FINAL PLAT OF
"HILLSIDE PARK"

RE: S/D 99-75 -- One-Step Final Plat of HILLSIDE PARK ADDITION

RE: S/D 99-75 -- One-Step Final Plat of HILLSIDE PARK ADDITION

STAFF REPORT
(One Step Final Plat Approved 11/18/99)

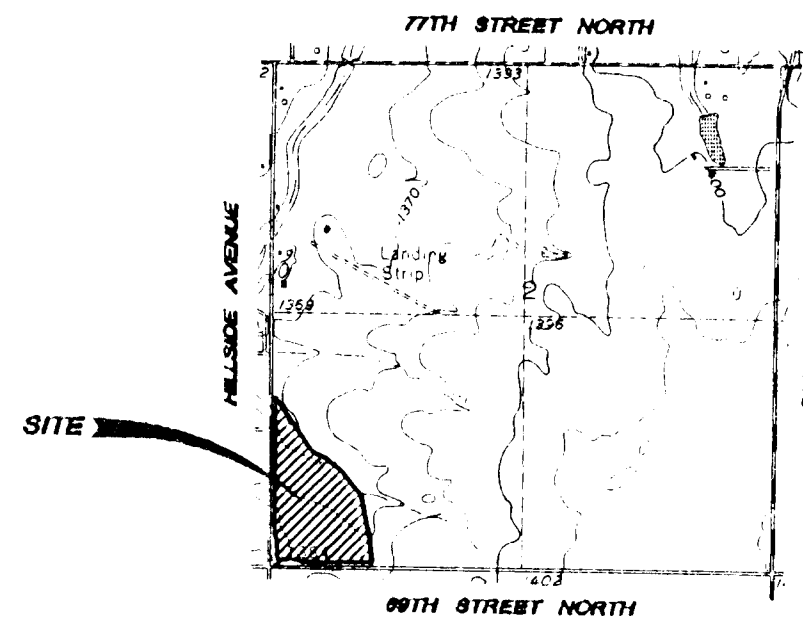
- C. County Engineering needs to comment on the status of the applicant's drainage plan. The drainage plan is approved.
- D. County Engineering needs to comment on the access controls. The face of the plat shall denote the access controls as referenced in the plat's text. The plat's text shall be revised to reference the "west" line of Lot 2. County Engineering has required 350 feet of complete access control from the section corner.

- E. The MAPC Chairman needs to be revised to reference "Francis S. Garofalo".

- I. The platting text shall include language that a drainage plan has been developed for the plat and that all drainage easements, rights-of-way, or reserves shall remain at established grades or as modified with the approval of the applicable City or County Engineer, and unobstructed to allow for the conveyance of stormwater.

- K. The applicant's engineer is advised that the Register of Deeds is requiring the name(s) of the notary public, who acknowledges the signatures on this plat, to be printed beneath the notary's signature.

CASE NUMBER: S/D 99-75 -- HILLSIDE PARK ADDITION

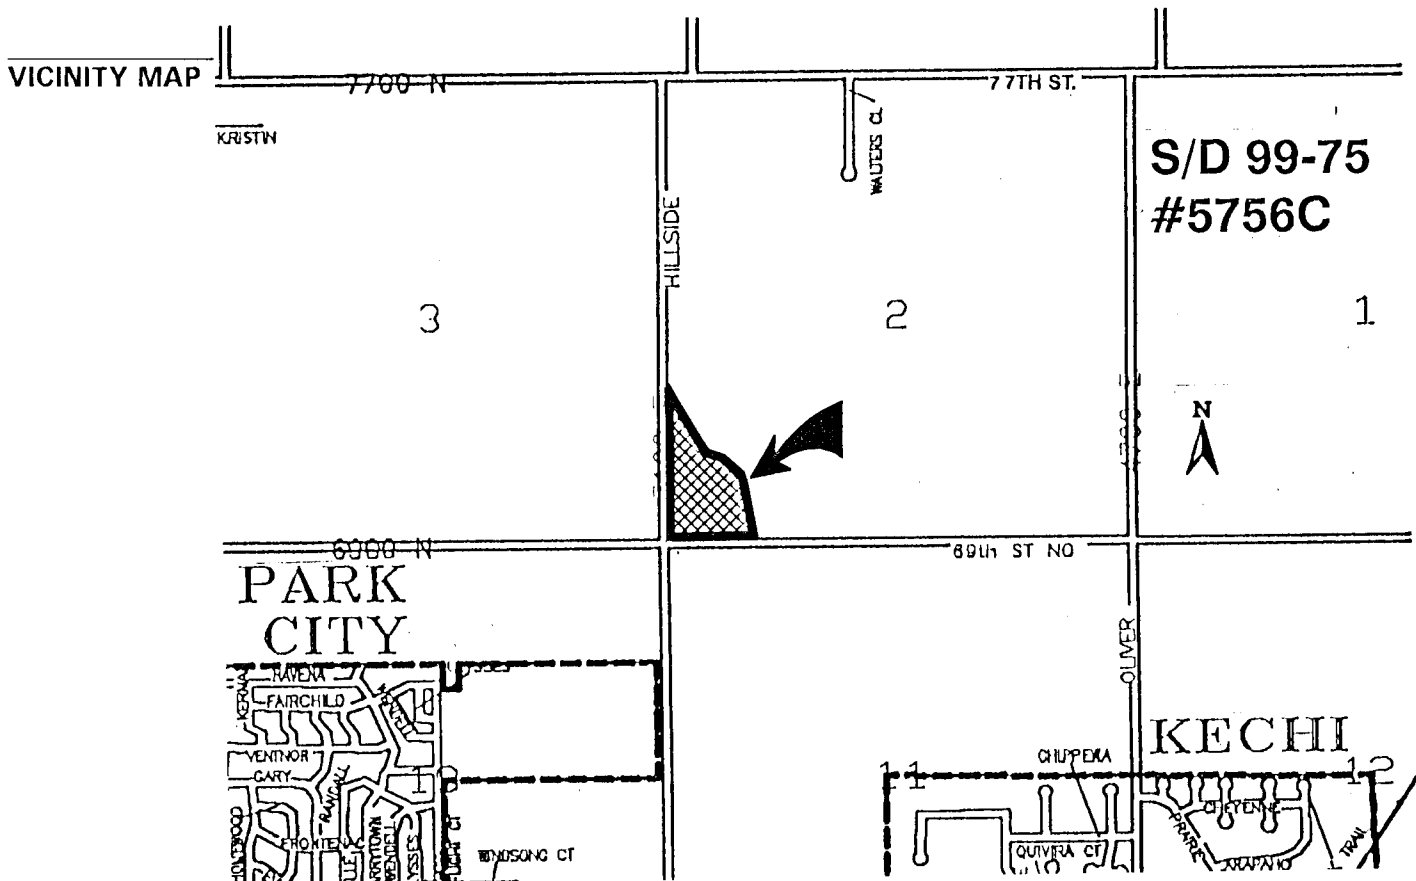
- A. Since sanitary sewer is not available to serve this property, the applicant shall contact the Environmental Health Division of the Health Department to find out what tests may be necessary and what standards are to be met for approval of on-site sewerage facilities. A memorandum shall be obtained specifying approval. Standard soil testing is required.

- B. The site is currently served by Rural Water District No. 2. The applicant shall contact this water district to determine the ability of this property being platted to connect to their water line and submit a letter from the water district regarding any requirements. The Applicant will not be connecting to the rural water line and on-site water facilities will be needed.

- C. County Engineering needs to comment on the status of the applicant's drainage plan. The drainage plan is approved.
- D. County Engineering needs to comment on the access controls. The face of the plat shall denote the access controls as referenced in the plat's text. The plat's text shall be revised to reference the "west" line of Lot 2. County Engineering has required 350 feet of complete access control from the section corner.

- E. The MAPC Chairman needs to be revised to reference "Francis S. Garofalo".
- F. If platted, the building setback may be reduced to 35 feet.
- G. For those reserves being platted for floodway purposes, a covenant shall be required which provides for ownership and maintenance of the reserves and shall grant, to the appropriate governing body, the authority to maintain the floodway reserves in the event the owner(s) fail to do so. The covenant shall provide for the cost of such maintenance to be charged back to the owner(s) by the governing body.

- I. The plat's text shall include language that a drainage plan has been developed for the plat and that all drainage easements, rights-of-way, or reserves shall remain at established grades or as modified with the approval of the applicable City or County Engineer, and unobstructed to allow for the conveyance of stormwater.
